Re: Proposed mixed use residential development of 1,250 no dwelling units, creches, community hall, retail and assoc. site works including Grange House at the Kishoge Development area of Clonburris SDZ In the townlands of Kishoge, Esker South, Grange and Balgaddy, Clonburris, County Dublin

Date: 11th July 2025.
Planning Application, No: JA06S.322638.

Development: Proposed residential development at the Kishoge Development area of Clonburris SDZ.

Re: Proposed residential development at the Kishoge Development area of Clonburris SDZ (Planning Application, No: JA06S.322638.)

Access Gate Location

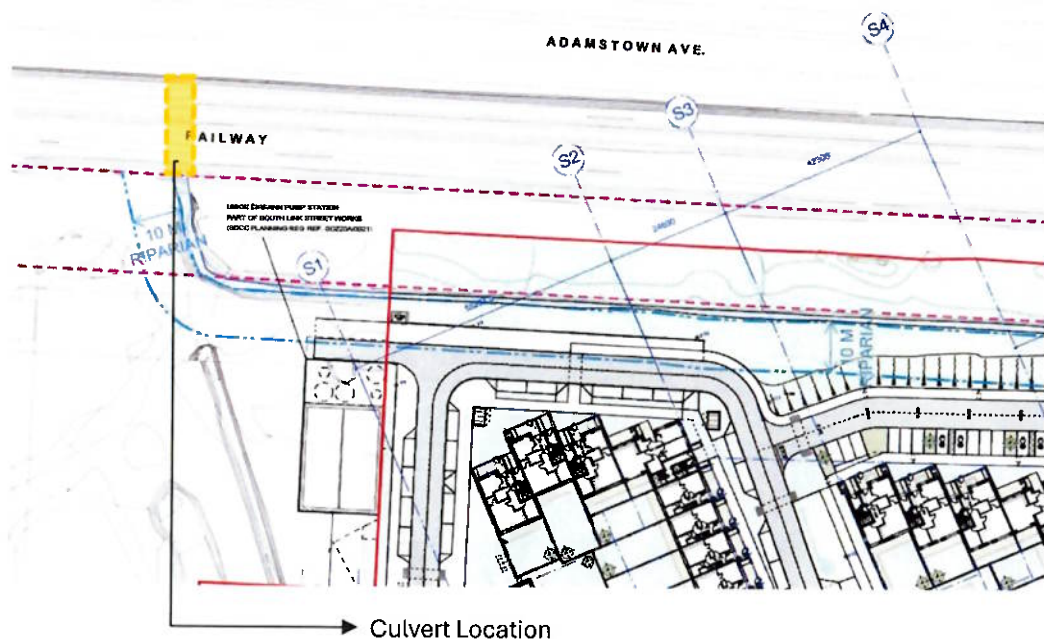
- 7) C.I.É owns a section of Lynch's Lane, which historically formed part of a former railway crossing. This lane currently provides essential access to a gate leading to the existing signalling room and other critical railway infrastructure. Iarnród Éireann requests that construction activities ensure this access route is maintained and kept clear at all times, both throughout the construction phase and following project completion, to guarantee uninterrupted operational access. Permanent, long-term access to the railway infrastructure via Lynch's Lane must be preserved.

Excerpt from Railway Order Property Plans, DART+ South West

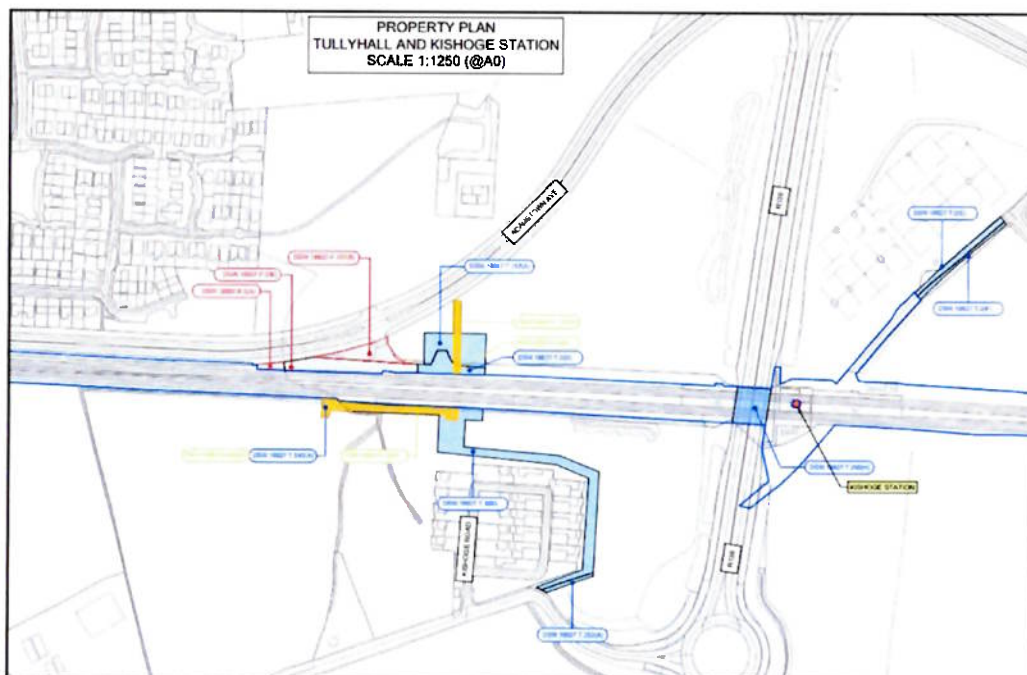
The proposed development of SDCC "Site 3" overlaps the approved DART+ South West permanent land acquisition, temporary land acquisition and right of way or easement.

The housing development must take these CPO requirements into consideration.

The housing development proposal as presented, does not provide sufficient space to accommodate the utility diversion works approved by the Railway Order.

As it stands, the temporary land acquisition and right of way CPO in the approved Railway Order gives Iarnród Éireann exclusive rights for use of the land for said purposes.

Excerpt from Railway Order Works Plans, DART+ South West

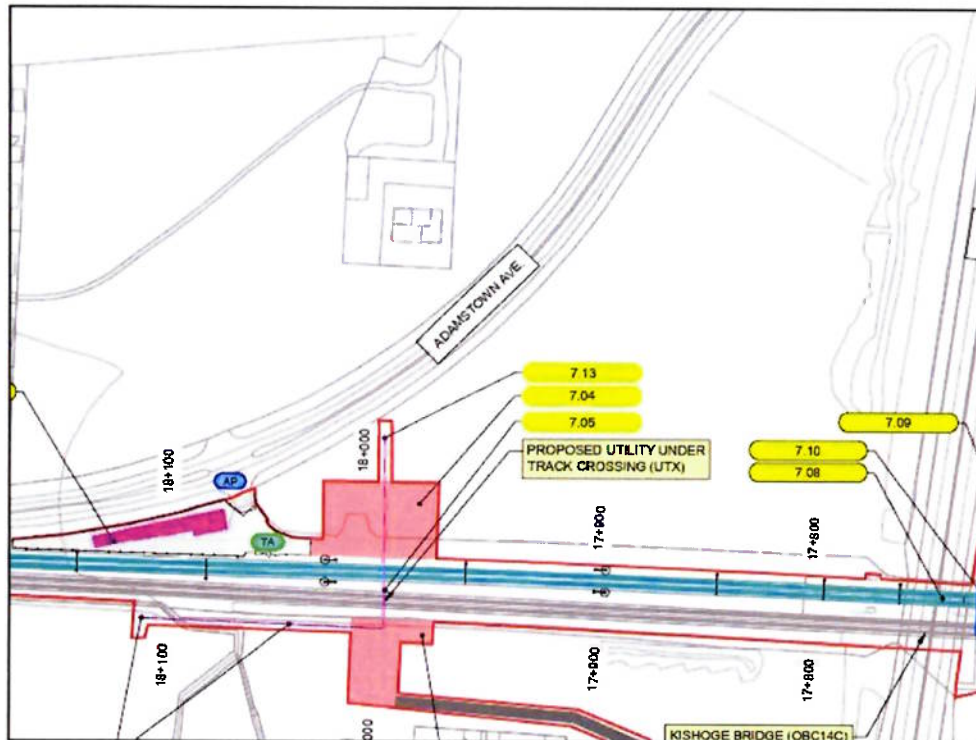
- is required for a 38kV electrical traction substation; to enable electrification of the 2 No. northern DART lines. The substation will be located within a dedicated compound. A permanent access will be provided from existing Adamstown Avenue; using what is currently a bell-mouth entrance to the lands.

- is required for the diversion of 2no. existing 10kV track crossings; at approx. chainages 18+000 and 18+110. This land includes for the access route to the launch and receiving pits, the diversion route and for substation works compound. The compound will facilitate the undertrack crossing diversions and the ducting for a future 38kV crossing for ESB to a cable route to the substation from "Site 1" and through "Site 3".

- At CH18+110 the existing undertrack crossing is proposed to be diverted from existing pole to south of railway in an eastward direction and along the southern railway corridor boundary (within the "SITE 1" development) to the proposed new CH17+995 railway crossing duct bank crossing. This would then head north up through "SITE 3" (the development under review) to connect to the same supply route (located within the development lands, as indicated in the existing ESB cable plans provided to Irish Rail).

- The 2nd diversion is the undergrounding of the existing overhead crossing at CH18+000 which was proposed to be undergrounded immediately adjacent to the overhead crossing at approx. CH17+995 also using horizontal directional drilling and also and connected on either side to the existing overhead networks using a section of underground cable and pole installation.

- The temporary land acquisition is also to account for installing the 38kv ducts across the railway corridor; required for a future ESB power supply to the substation. The early installation of ducting will serve to limit future impact on the developments which would require the potential demolition of road for launch and receiving pits.

Excerpt from Railway Order Property Plans, DART+ South West

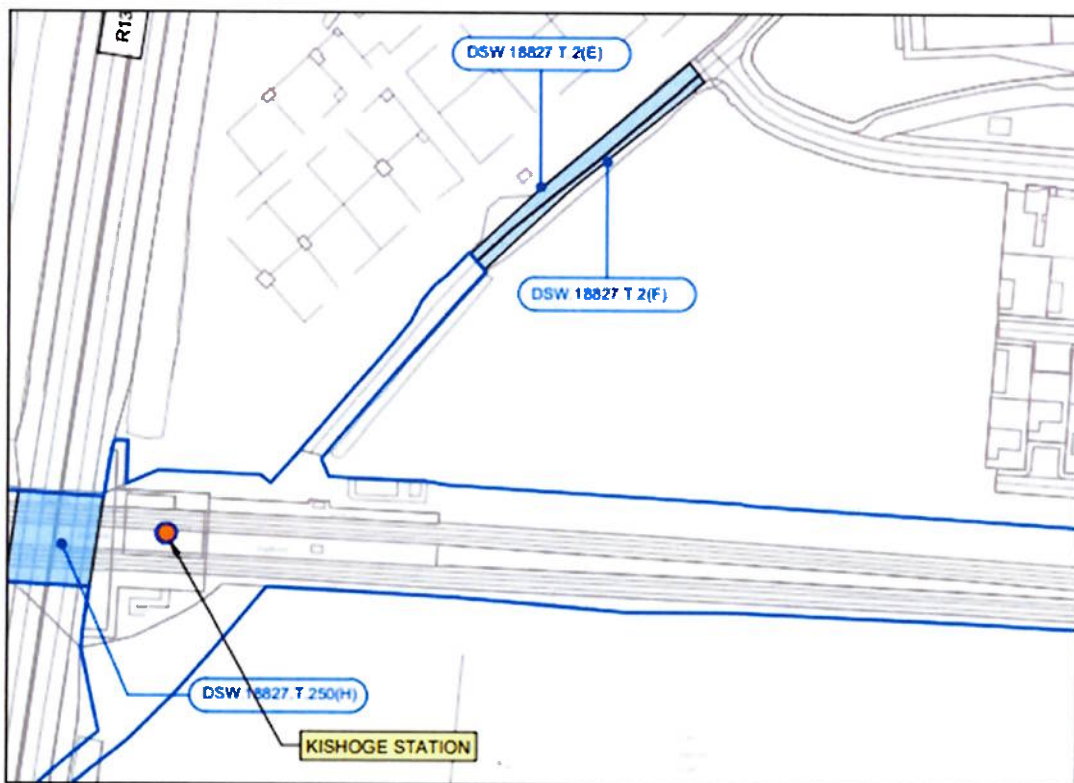
A temporary land acquisition is included along the access lane to the rail line in the vicinity of the proposed housing scheme. This is to ensure that access to the DART+ South West construction site, and to the railway track, is enabled during the construction period. Without track access, construction of the DART+ cannot proceed.

- 18827.T.2(E) – 464.9 sq. m – Ownership of SDCC – Lynch Lane, Kishoge
- 18827.T.2(F) – 269 sq. – Ownership of SDCC – Lynch Lane, Kishoge

The housing development must take these CPO requirements into consideration.

Excerpt from Railway Works Plan, DART+ South West

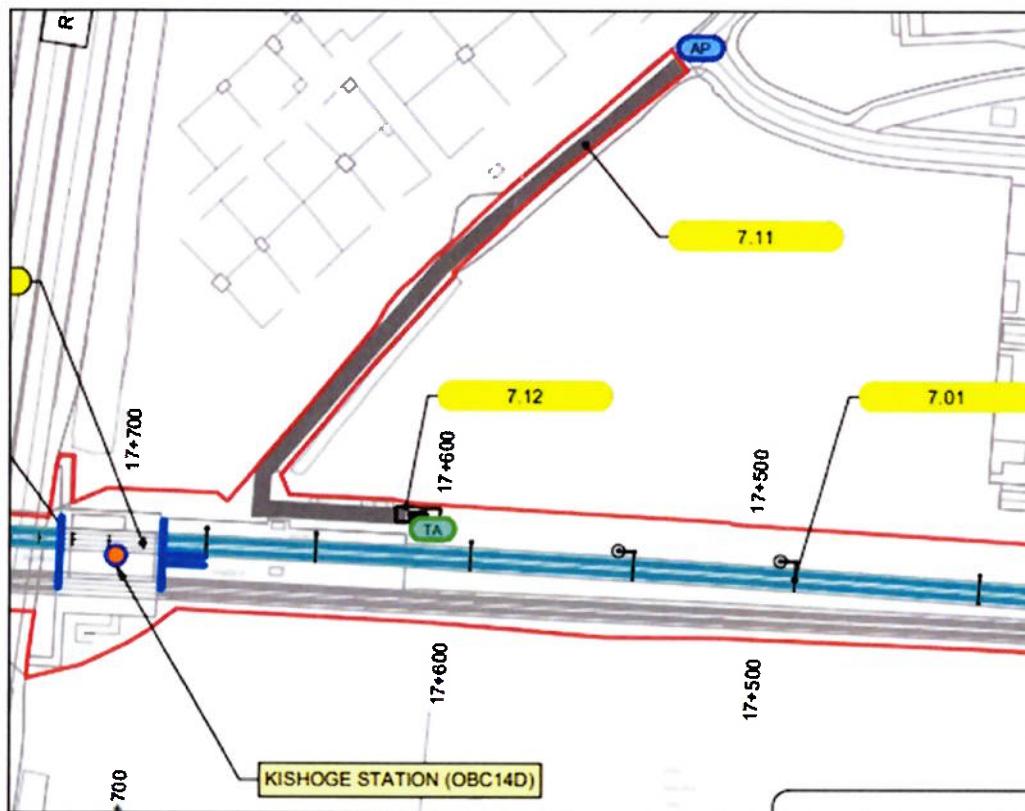
- The approved DART+ South West Railway Order indicates an existing permanent track access point (TA) at the end of the access road to the railway corridor; both the access road and track access point are to be retained for future operational and maintenance requirements of the electrified railway.
- The Railway Order enables IÉ to re-gravel and re-grade the existing access lane, as necessary, to access the rail line during the construction period (Works No. 7.11)

Construction of the DART+ South West project requires access to the rail line at this location, in addition to its maintenance and operational function purposes. This needs to be guaranteed notwithstanding housing construction requirements and phasing; and should be sufficient for articulated long wheel base flatbed trucks to use.

The access road connectivity interface between the private road (along which CIE has a right of way) and the road within CIE lands; seems to be severed by a road bend in the proposed development. This connectivity must be uninterrupted, details of the same should be provided and agreed with IE (at grade connection on the road bend, or dished

The site layout indicates a future connection road over CIÉ lands that will form part of the scheme. and also seems to encroach onto CIE Lands. Developer to confirm that no development on CIÉ land is proposed as part of the application.

There is no detail presented on the proposed boundary treatment along the access lane and at the interface of the CIÉ and SDCC lands at Lynch Lane. An appropriate boundary treatment conforming to Iarnród Éireann Standards should be included along the CIÉ lands on Lynch's Lane. This should include for vehicular gates and/or integrated pedestrian gate as will be stipulated by Irish Rail at detailed design.
